**UNITED STATES
NUCLEAR REGULATORY COMMISSION**
WASHINGTON, D.C. 20555-0001

NOTE TO FILE: Project File: PROJ0734

SUBJECT: SUMMARY AND PRELIMINARY COMMENTS ON DOCUMENTS
PROVIDED BY THE UNITED STATES DEPARTMENT OF
ENERGY IN SUPPORT OF THE F-TANK FARM AND H-TANK
FARM FACILITY PERFORMANCE ASSESSMENTS

Summaries and Preliminary Review Comments on DOE SRS Tank Farm PA Documents

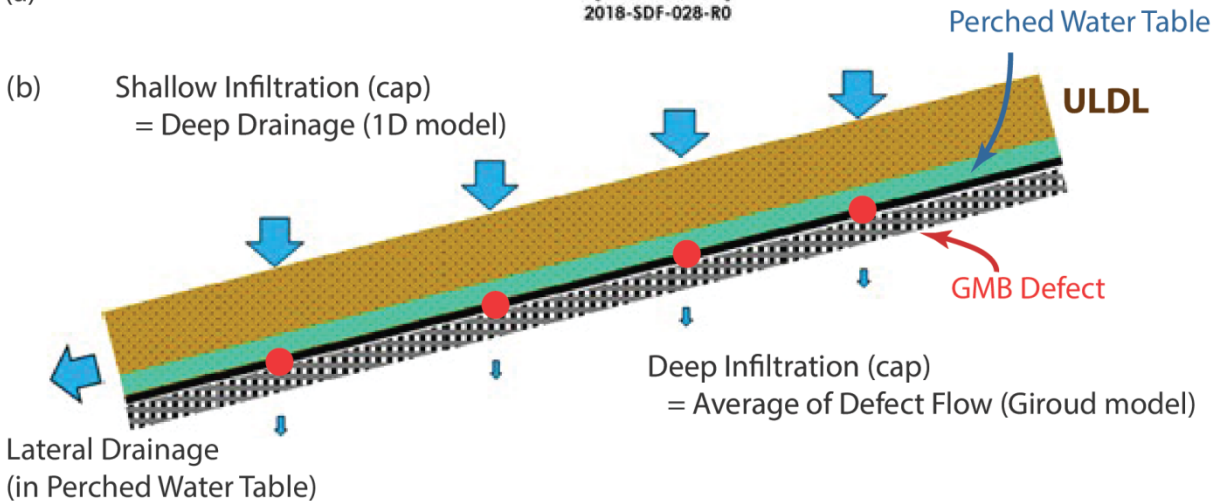
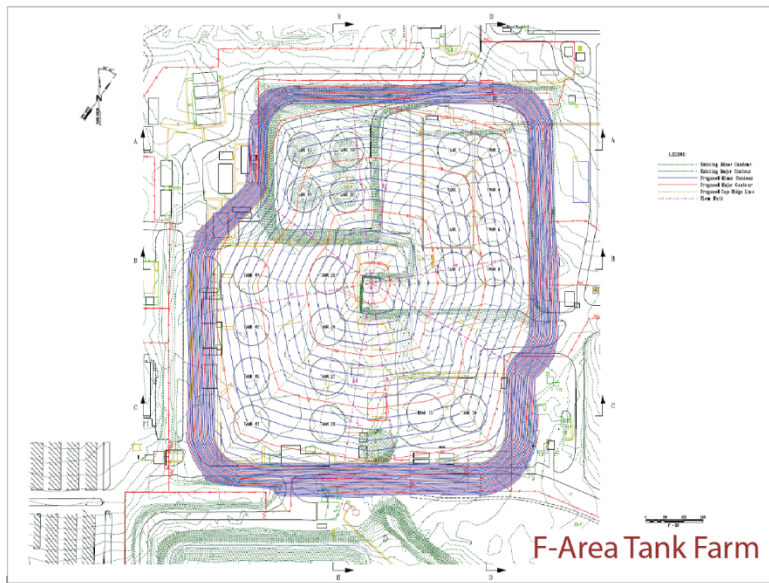
The GoldSim equations do not consider uncertainty in backfill saturated hydraulic conductivity (K_{sat}). The simulation results of Gustitus and Benson (SRRA162682-000002, 2020) and Benson and Benavides (SRRA107772-000009, 2018) have rather different simulation results (Table 2) but the same input meteorology. NRC found no discussion of what drives the different inflow and ET values for the same meteorological record but identified a small change in the K_{sat} value used for the backfill and erosion barrier as a difference between the two. Gustitus and Benson (2020) calculate runoff as no more than 8 percent of precipitation, whereas Benson and Benavides (2018) calculate runoff as no more than 15 percent of precipitation. NRC staff hypothesize the smaller K_{sat} value may keep wetting pulses nearer the top of the cap, enhancing evapotranspiration. A factor of two is a relatively small difference in K_{sat} for natural porous media.

The sharper gradient means that the water table may rise high into the backfill, even potentially discharging to the cap surface. An elevated water table has consequences for the near-surface water balance because less infiltration capacity is available during precipitation events (increasing runoff), thus the changed water balance is likely to increase cap erosion rates. Furthermore, focused upwelling may provide conditions that promote localized erosion, such as gullying, that is not considered in the analysis. Once a gully is initiated, it may propagate upslope beyond the area affected by an elevated water table.
